WORTH COUNTY BRIDGES - CULVERTS

STATE OF IOWA
STATE HIGHWAY COMMISSION
DESIGN FOR
BRIDGES CULVERTS
INTERSTATE ROAD SYSTEM
PROJ. I-35-8(6)206--01-98
WORTH COUNTY

CONSTRUCTION PLANS SHOWING PROJECT AS BUILT

LISTING OF PROJECT REVISIONS

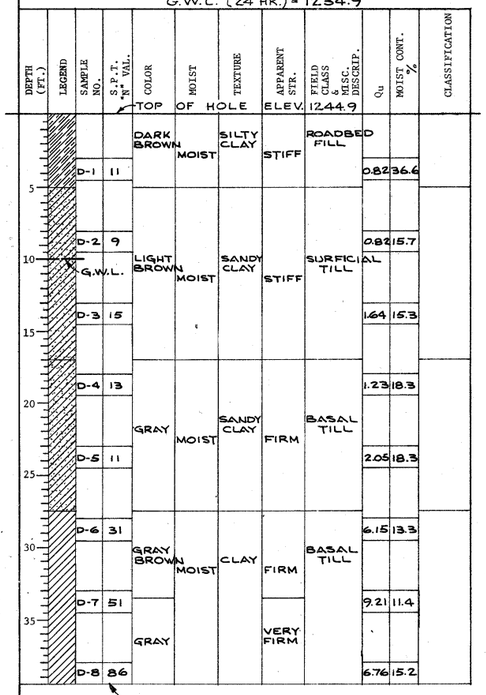
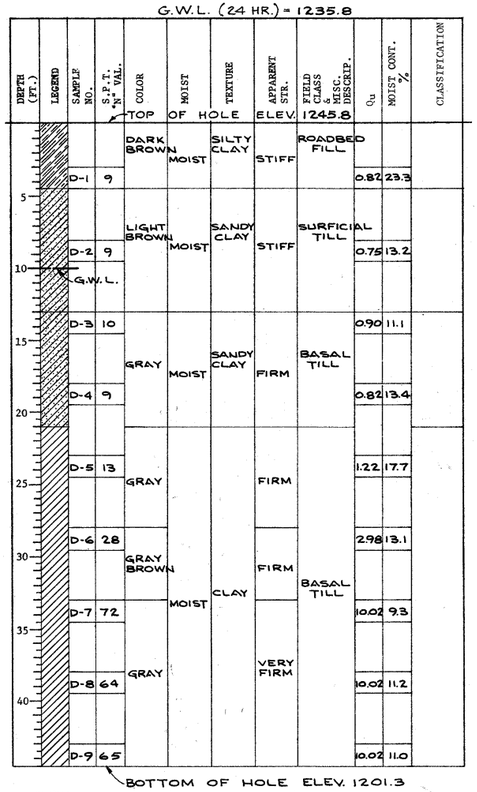
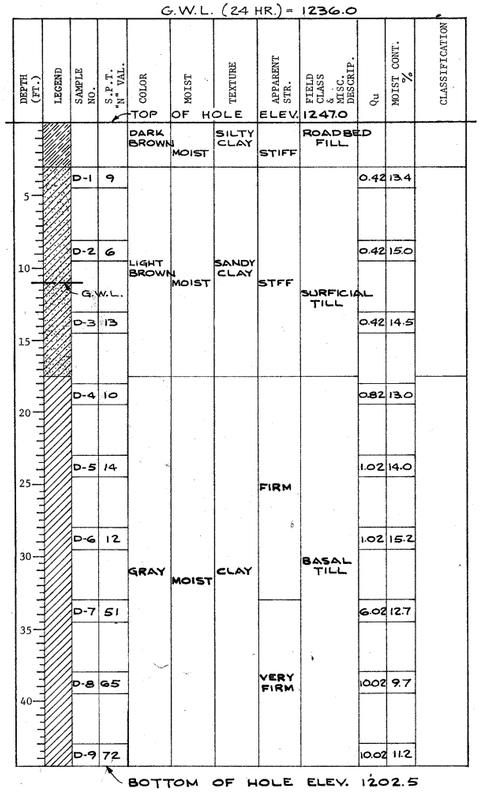
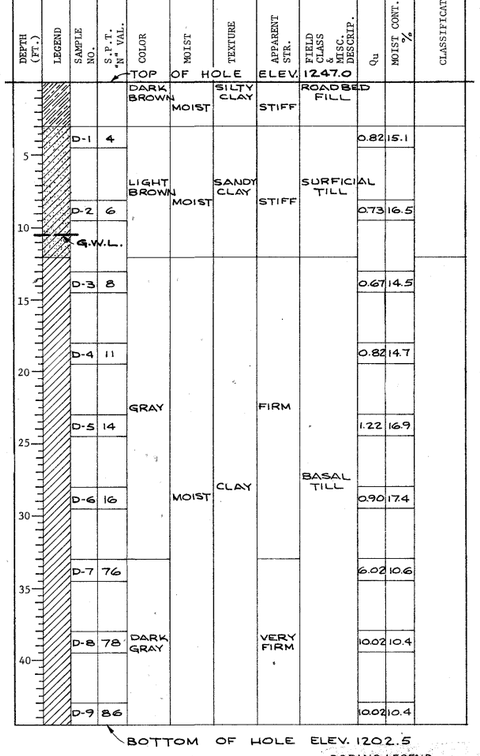
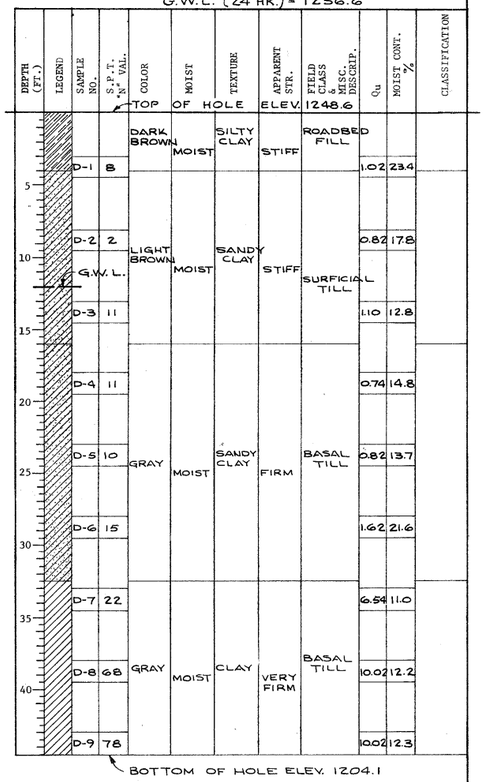
B. REASON - A CREOSOTED TEST PILING 25' LONG WAS DRIVEN IN THE SOUTH COLUMN FOOTING OF PIER NO. 2 AS REQUIRED ON THE OFFICIAL PLANS. A 12 TON BEARING WAS ATTAINED AT FULL PENETRATION. THE MINIMUM SPECIFIED BEARING VALUE IS 20 TONS, THEREFORE; THE ENGINEER IS ORDERING A 35' CREOSOTED TEST PILING TO BE DRIVEN TO OBTAIN FURTHER BEARING INFORMATION BEFORE ORDERING ADDITIONAL LENGTH PILING.

B. REASON - THE PILE LENGTHS ON THE PROJECT PLANS WERE ESTIMATED FOR BIDDING PURPOSES ONLY. A TEST PILE, (CONTRACT ITEM NO. 63) DRIVEN IN PIER 2 INDICATES THAT THE INCREASED LENGTHS DESCRIBED ABOVE WILL BE NECESSARY TO OBTAIN THE MINIMUM REQUIRED BEARING.

WEST ABUTMENT	- 12 @ 45'	= 540 LIN. FT.
PIER 1, 2, AND 3	- 73 @ 30'	= 2190 LIN. FT.
EAST ABUTMENT	- 12 @ 45'	= 540 LIN. FT.
		3,270 LIN. FT.

Design No. 568A Sta. of C.L. 370 + 14.29

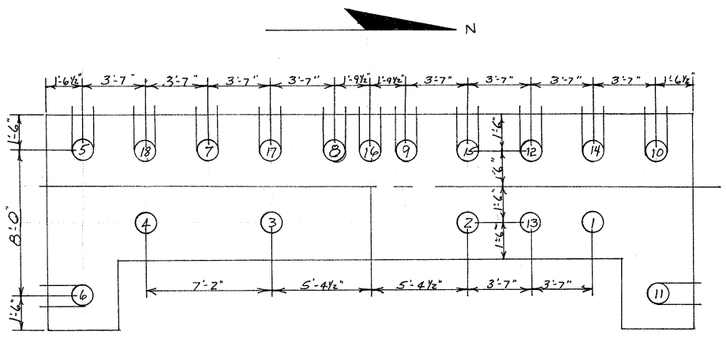
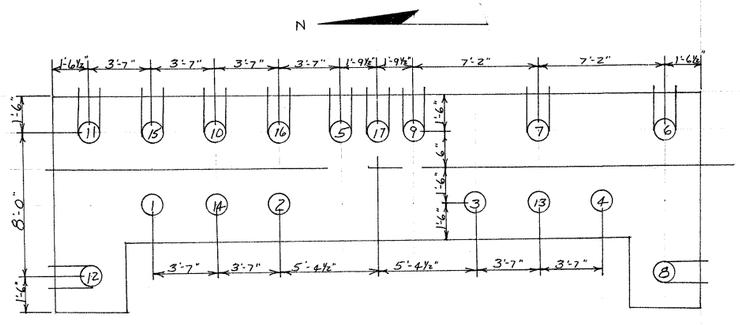
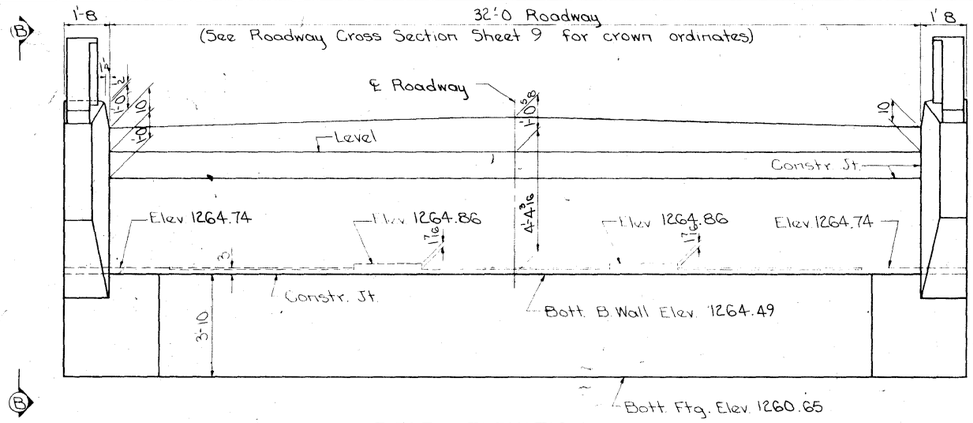
Remarks: Piles battered 1:4 in direction shown.
Ames office okayed 11 additional 55' piling, 6 in the East Abut. and 5 in the West Abut.

Final Pay Quantity = 863.45 L.F. @ $2.75 = $2374.49

Final Pay Quantity = 812.25 L.F. @ $2.75 = $2233.74
